ADDENDUM NO. 01-R1

PROJECT: Flint High School

DESCRIPTION: Primary Steel & Electrical Equipment of the new Flint High School

Attention: Construction Manager & ALL Bidders
Reference: Addendum No. 01 - TO BID PACK 02A

1 SPECIAL JOIST DIAGRAM

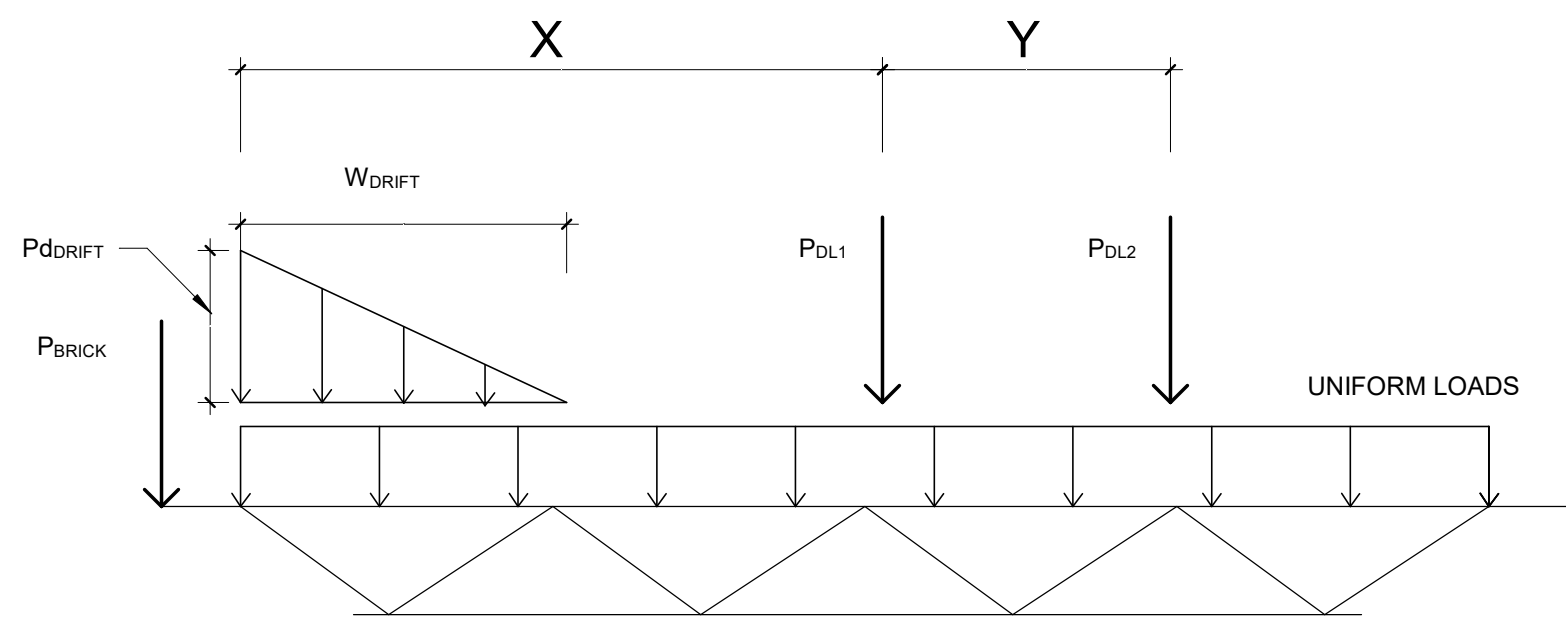
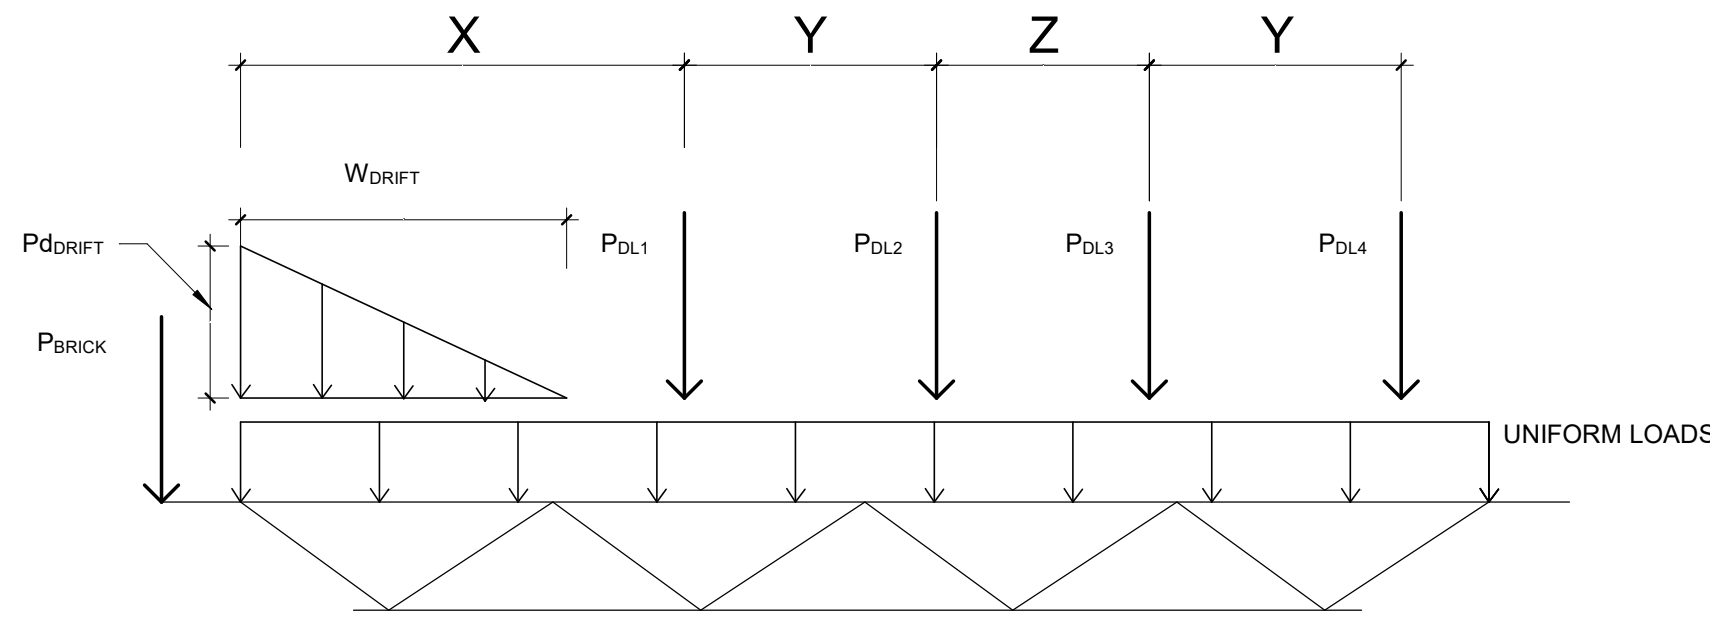
- Item S1: 3-S005 (re-issued)
- A. Updated Snow Drifting Loads
- Item S2: 3-S005A (re-issued)
- A. Updated joist framing sizes
- Item S3: 3-S121B (re-issued)
- A. Updated joist tags/sizes
- Item S4: 3-S121E (re-issued)
- A. Added steel lintel for new opening in wall
 - B. Added connection loads
- Item S5: 3-ST201 (re-issued)
- A. Added sheet notes
- Item S6: 3-ST202 (re-issued)
- A. Added sheet notes
- Item S7: 3-ST211 (re-issued)
- A. Updated bracing connection loads

ELECTRICAL SINGLE LINE DIAGRAM

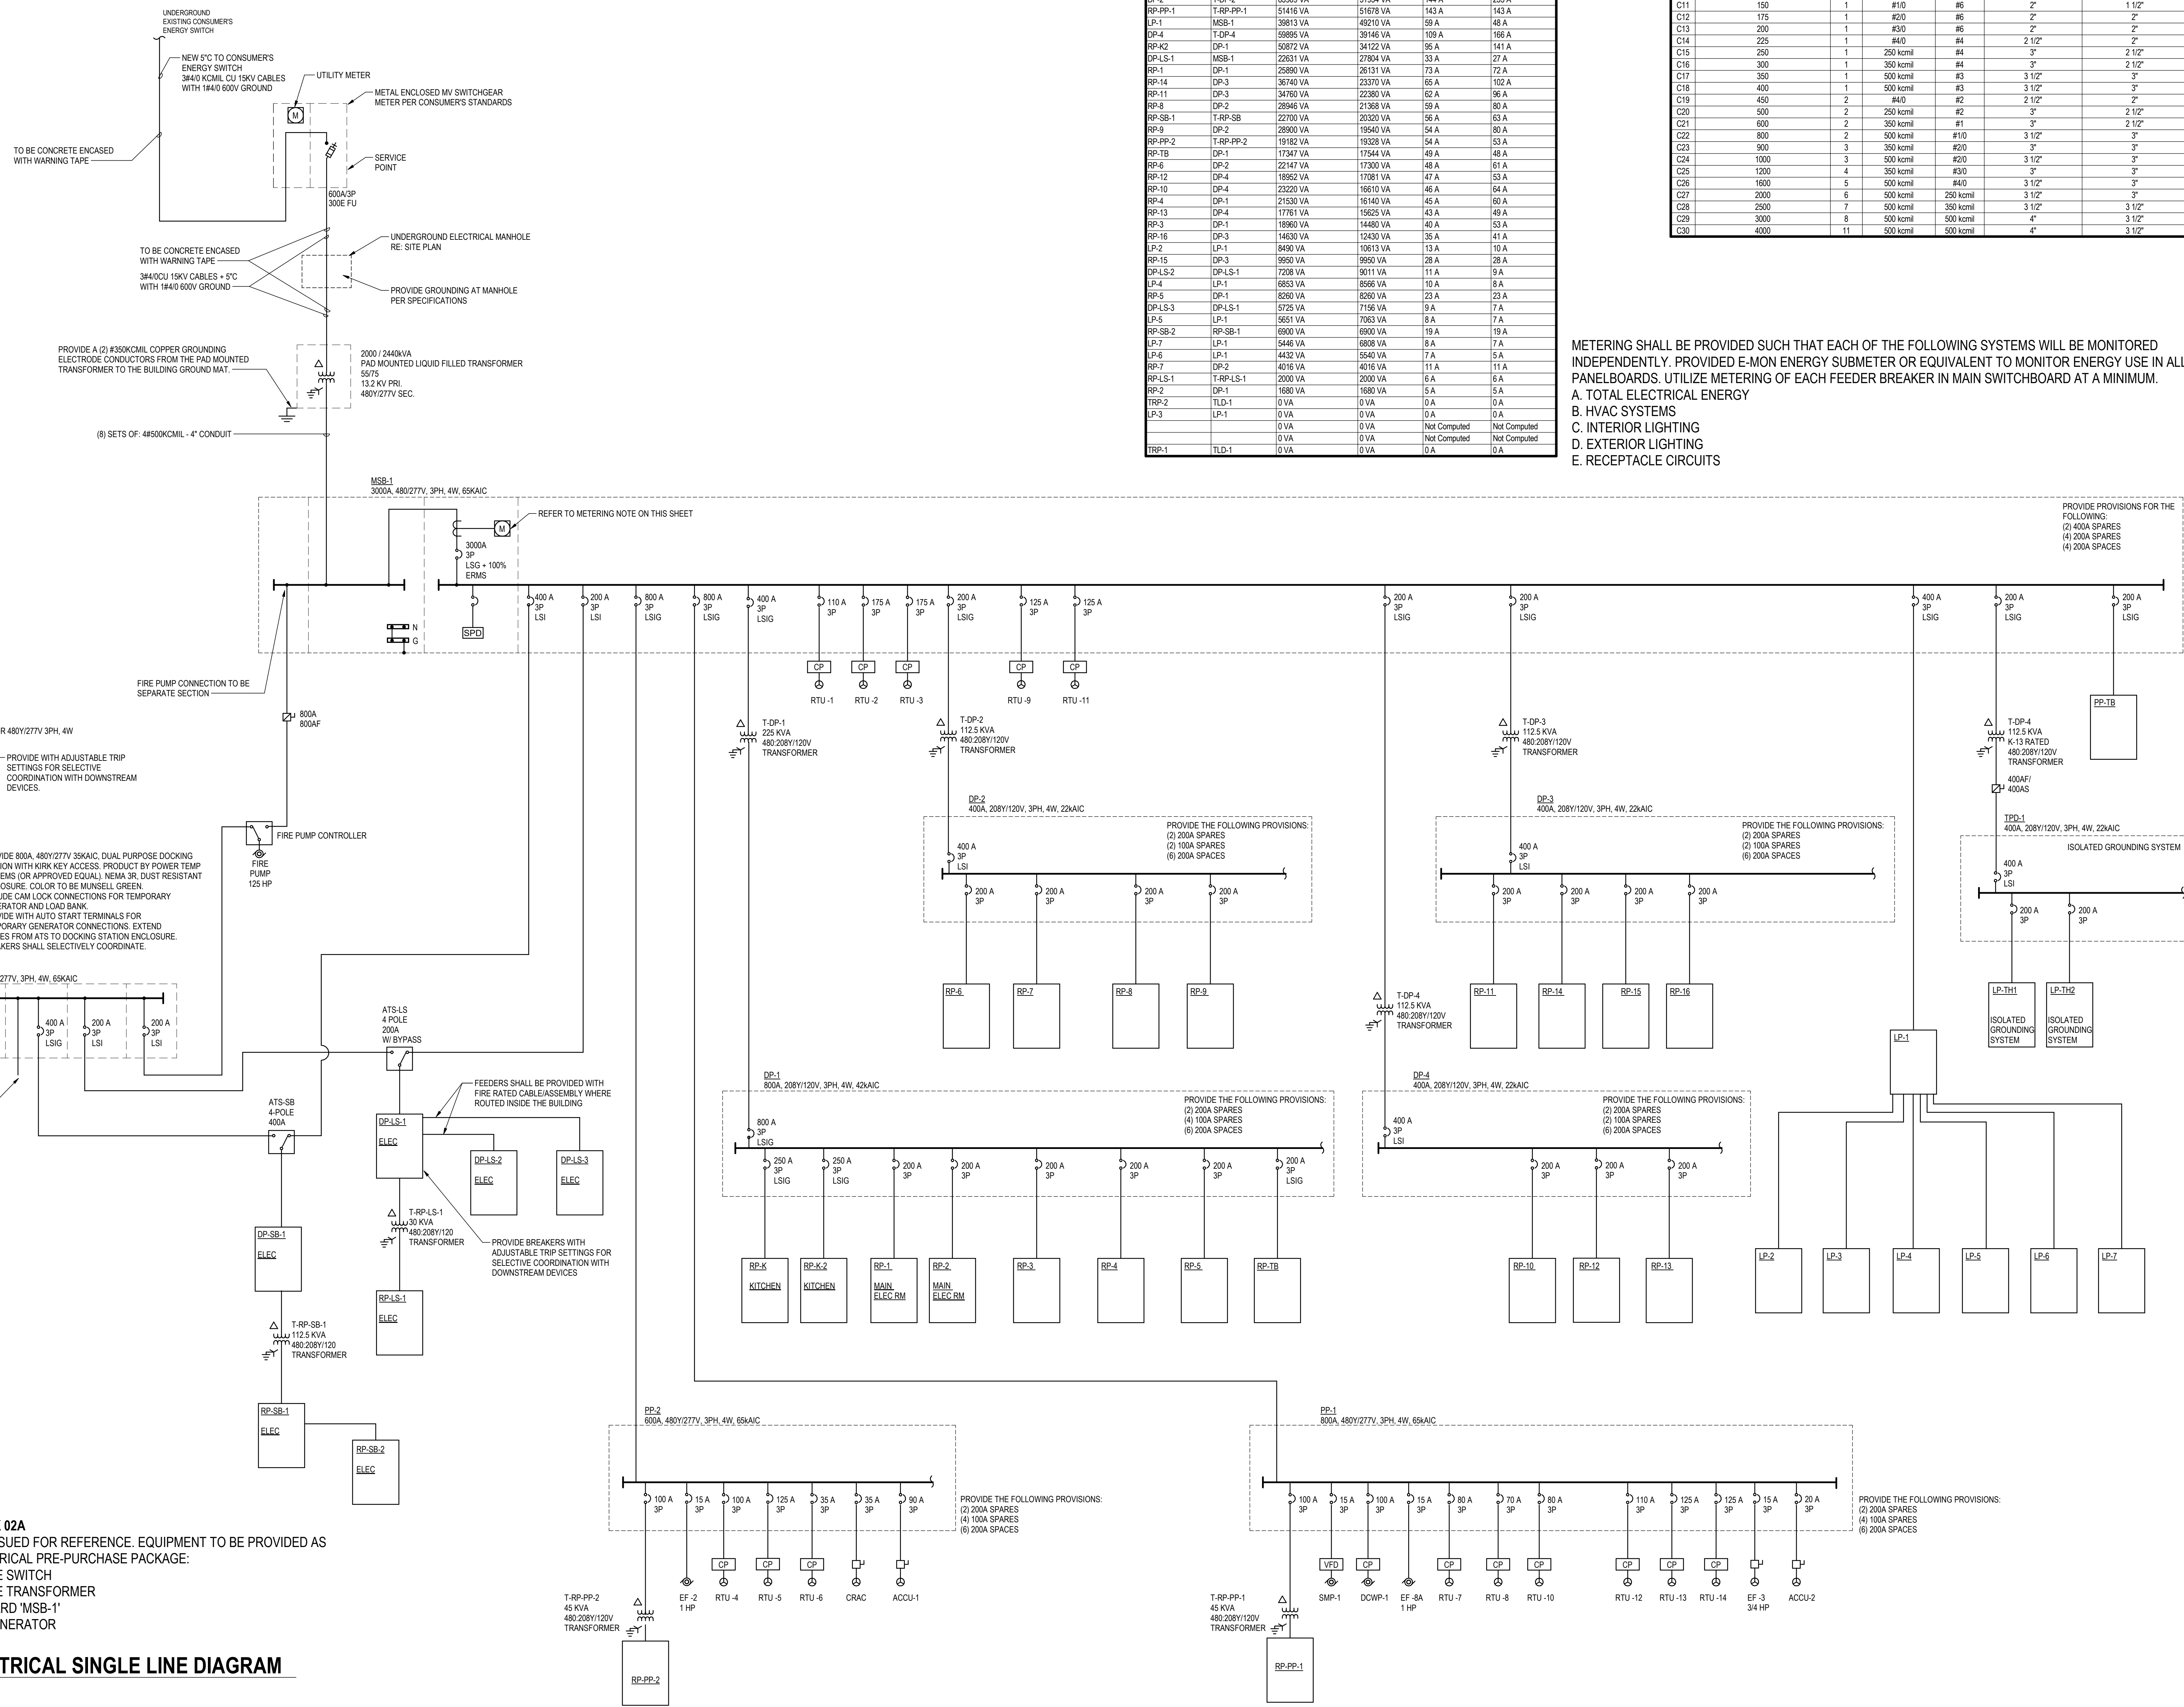
Item E1: 3-E401 (New Drawing)

A. Preliminary Drawing Issued for Electrical Pre-Purchase Package

NOTE FOR BID PACK 02A
FULL DRAWING IS ISSUED FOR REFERENCE. EQUIPMENT TO BE PROVIDED AS PART OF THE ELECTRICAL PRE-PURCHASE PACKAGE:
